## Addendum No. 1

### Invitation to Tender ES-21-06

#### SUPPLY AND INSTALL OF THREE CARDBOARD COMPACTORS

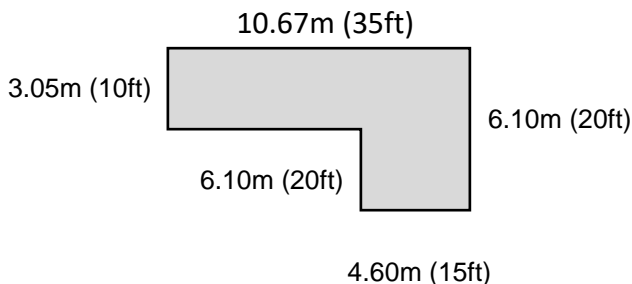
**Question #1:** Will the compactor & compaction container be mounted on a concrete pad for each of the three sites, and if so, is the size (L x W) available?

**Answer #1:** The compactors at the McBride & Valemount Regional Transfer Stations are on concrete pads. The new cardboard compactor for the Mackenzie Regional Transfer Station will be placed on a newly poured concrete pad. It is anticipated that this new pad would have similar dimensions to the existing pads. The dimensions of the concrete pad in Valemount are:
